Grading & Servicing Reviewed

Owner/Applicant
DCR/PHOENIX HOMES
Telephone # 723-9227
Plan # 4M- 1653
Project name: PATHWAYS
Civic Address: 276 GINEBIK
House model: ROSEMERE E

LOT 315 **SITE/GRADING PLAN**
PATHWAYS PHASE 2

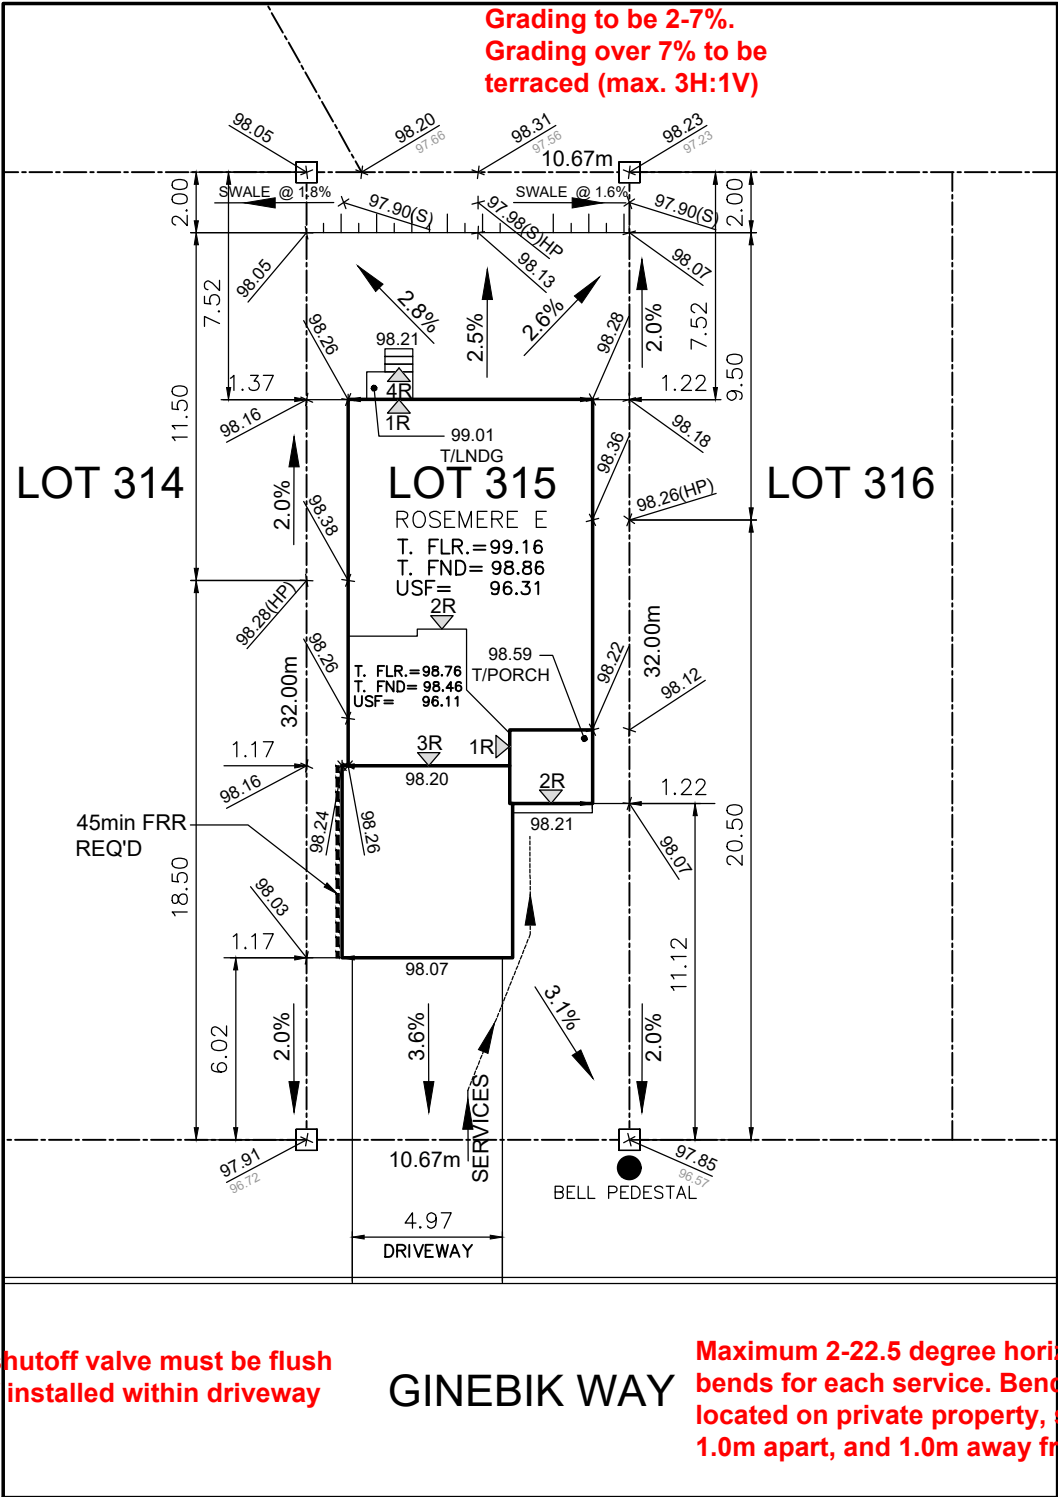
Sleeved services required under retaining walls / footings / garage, and are recommended under porches, decks, and similar structures

No excess drainage to be directed towards adjacent properties

Existing grading and drainage patterns must not be altered

Match existing elevations with abutting properties

Grading to be 2-7%.

Grading over 7% to be terraced (max. 3H:1V)

Top of water shutoff valve must be flush with asphalt if installed within driveway

Maximum 2-22.5 degree horizontal radius bends for each service. Bends must be located on private property, spaced min. 1.0m apart, and 1.0m away from all valves

This is a sensitive soils area. All sensitive soil issues related to this application are to be taken up with Building Code Services
